ADDENDUM NUMBER ONE (1)

Project: Ridgeland City Hall
City of Ridgeland
PN: 14084

FROM: Dean and Dean/Associates Architects, P.A.
4400 Old Canton Road, Suite 200
Jackson, MS 39211
(601) 939-7717

Sheet Number : C0.4

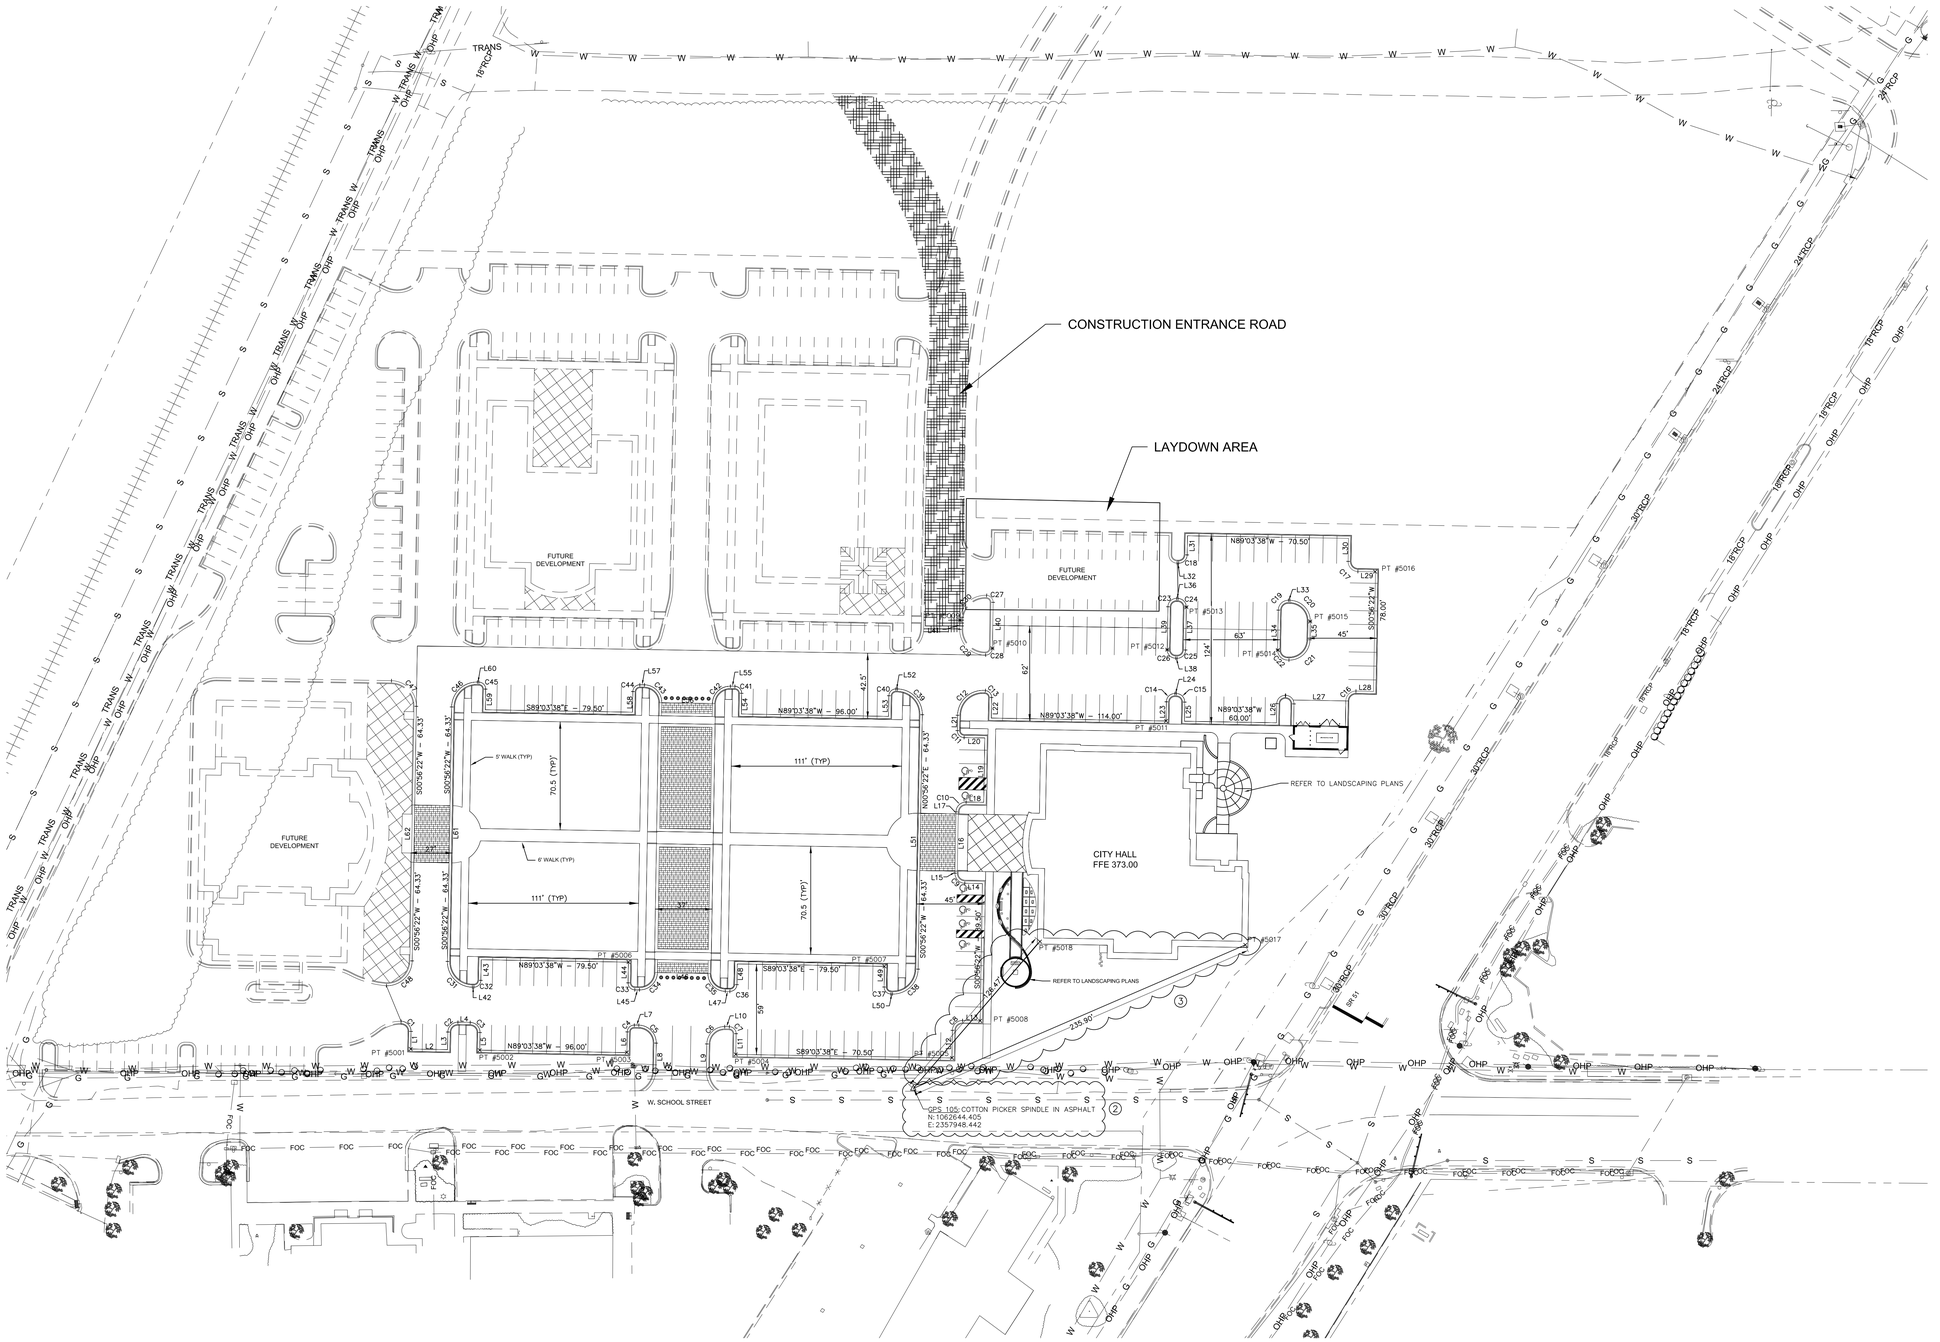
Sheet C0.4:

1. Detail C7
   - Concrete was changed from Class C to 3500 PSI
   - 2" Crushed Stone Base was removed
   - Geotextile Fabric was removed
   - Non-Expansive Clay Soil Buffer was changed from 34" to 36" depth.

2. Detail C7
   - Concrete was changed from Class C to 3500 PSI
   - Non-Expansive Clay Soil Buffer was changed from 78" to 84" depth.

3. Detail C4
   - Concrete was changed from Class C to 3500 PSI
   - Non-Expansive Clay Soil Buffer was changed from 19" to 24" depth.

4. Detail C4
   - Concrete was changed from Class C to 3500 PSI
   - Note revised to 11'x11' joints for center concrete pavement section and 11.5'x11.5' joints for left and right concrete pavement sections.

5. Detail C5
   - Concrete was changed from Class C to 3500 PSI
   - 12" Lime Treated Subgrade removed
   - Non-Expansive Clay Soil Buffer was changed from 67" to 84" depth.

Sheet Number:
C4.4

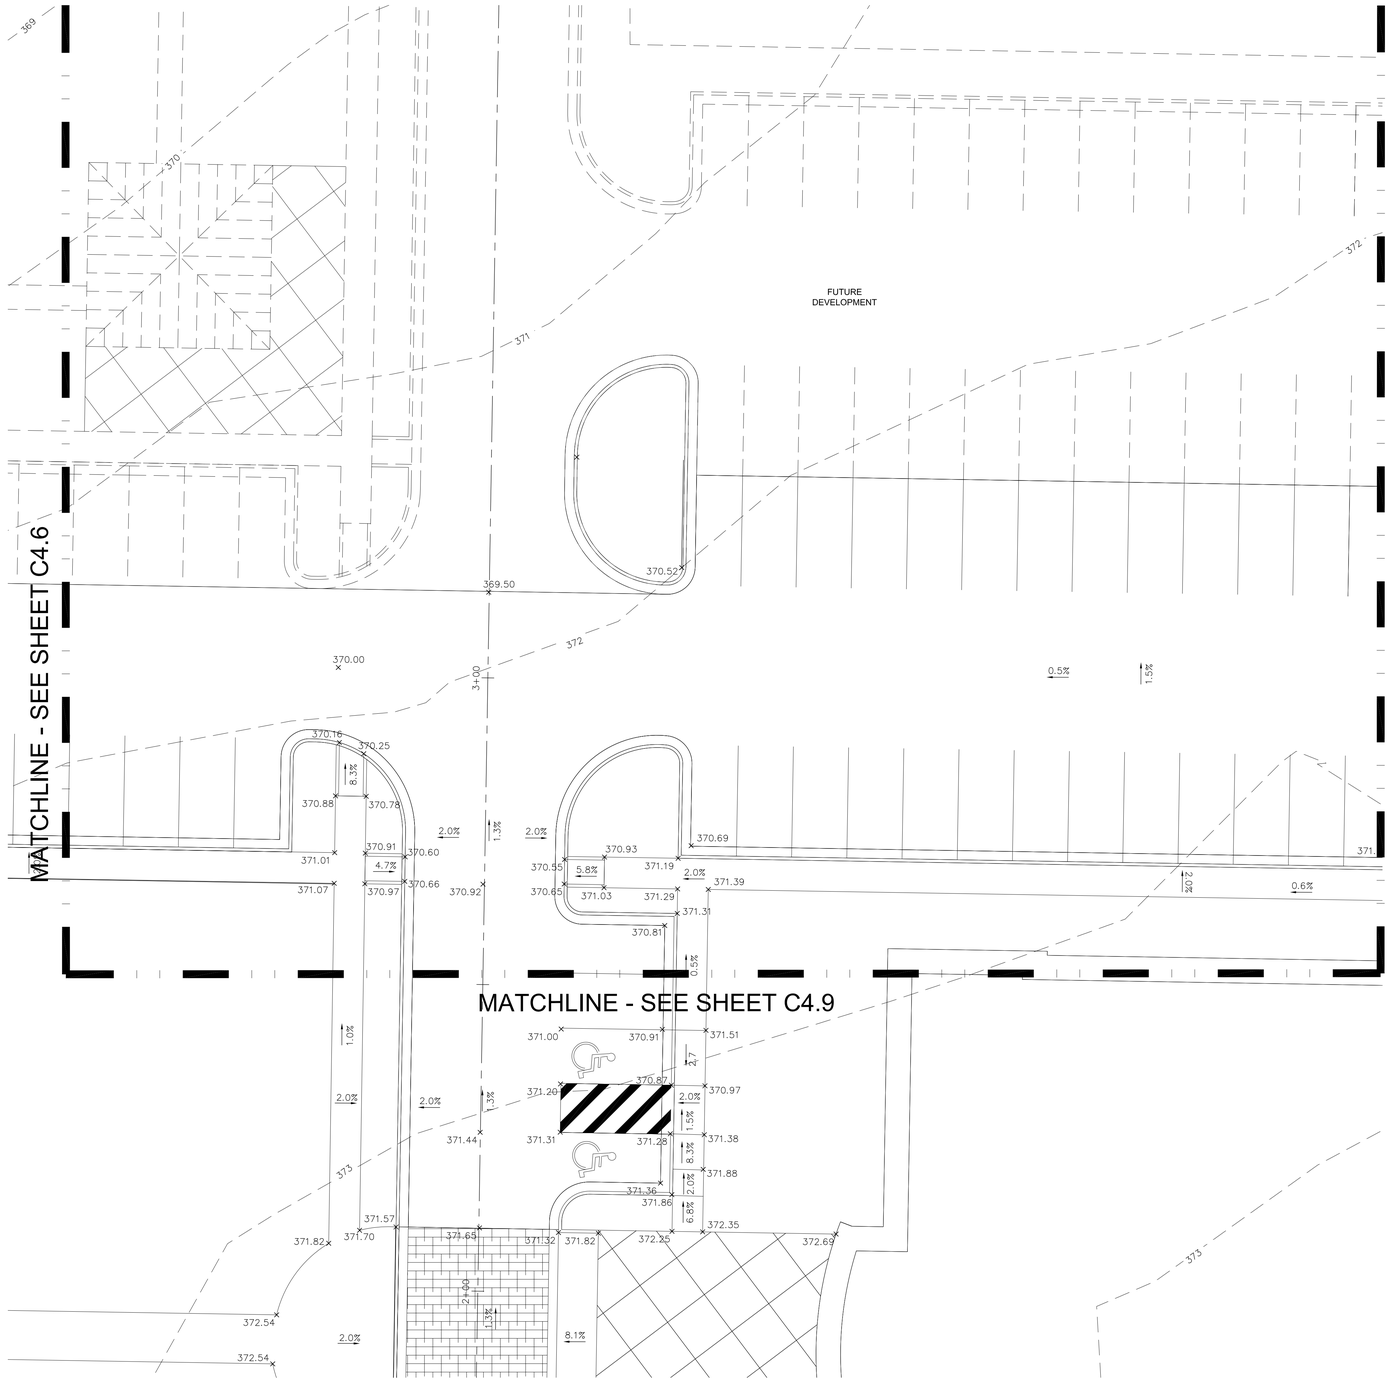
1. 6" PVC on south side of building was rerouted to the northeast side of the building to tie-in to Curb Inlet #6. As a result Drop Inlet #2 was removed and Inlets 1-8 were renumbered. Additionally, inlets were raised and profile for inlets and inverts were adjusted accordingly.
2. Inlets 9-13 were renumbered and raised, and profile for inlets and inverts were adjusted accordingly.
3. Drop Inlets 15 and 16 were renumbered.
4. 3" PVC from Mechanical Sheets was added and tied-in to Drop Inlet #6.
5. Pipe was changed from RCP to PVC
6. Note was added: "See Sheet L100A For Grades at Building"
7. Drop Inlet #2 was removed and inlets were renumbered and adjusted accordingly

Sheet Number : C4.9

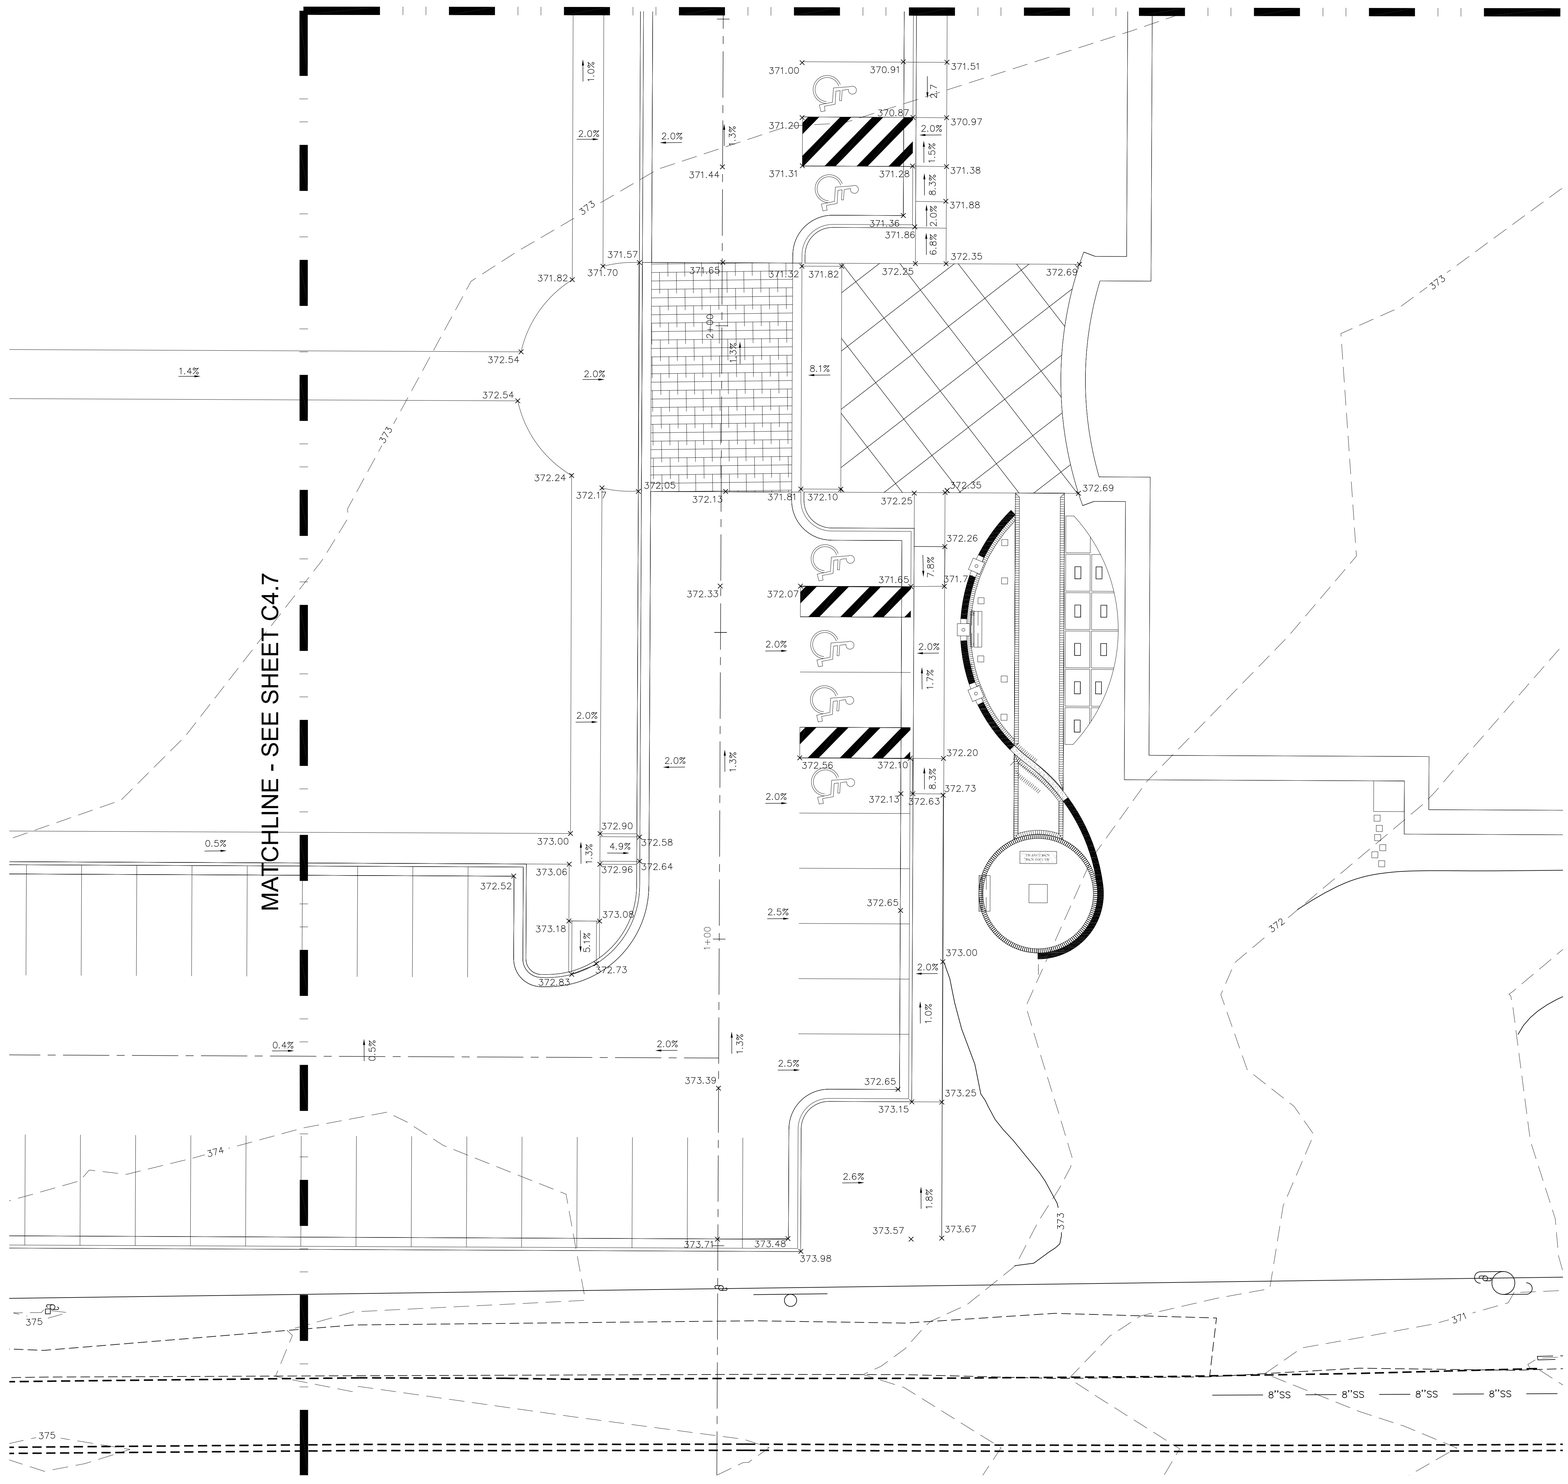
1. Note was added: "Refer to Sheet L100A for Grades at Building"

Sheet Number : C4.10

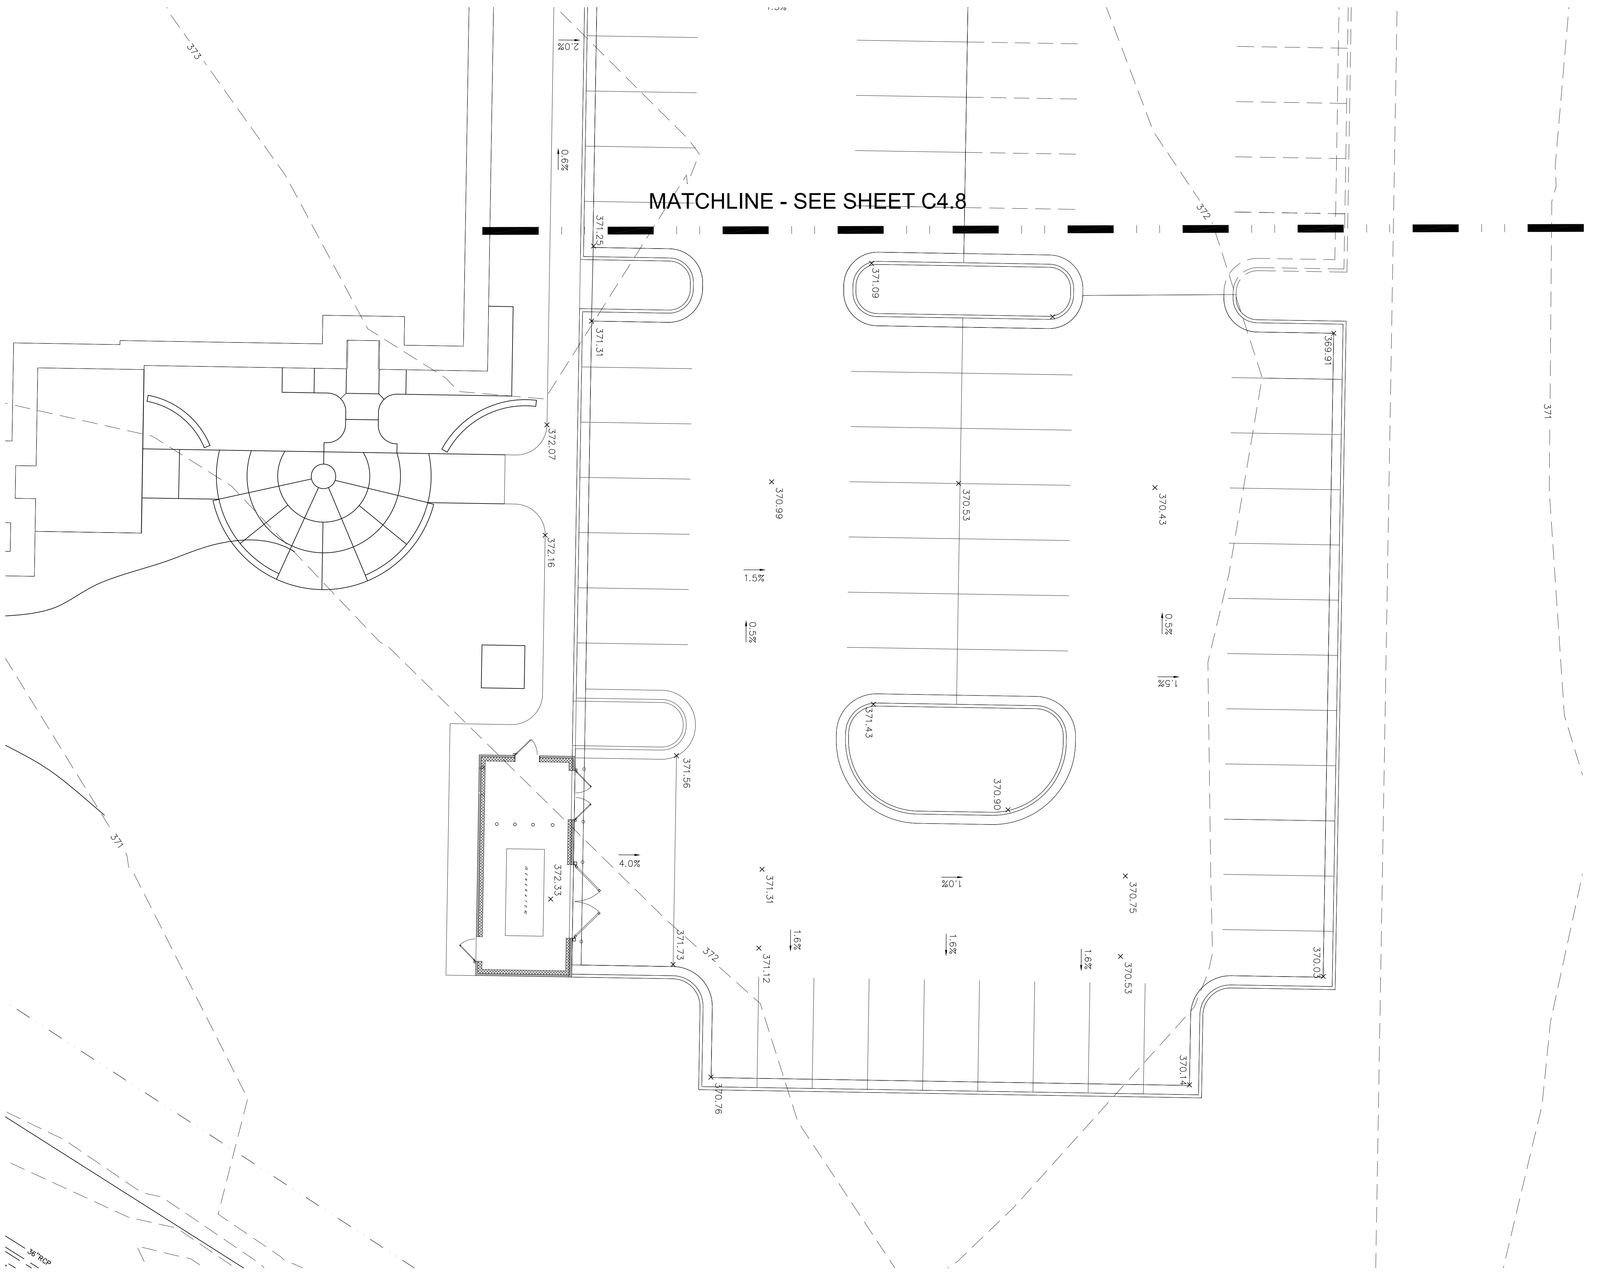
1. Note was added: "Refer to Sheet L100A for Grades at Building"
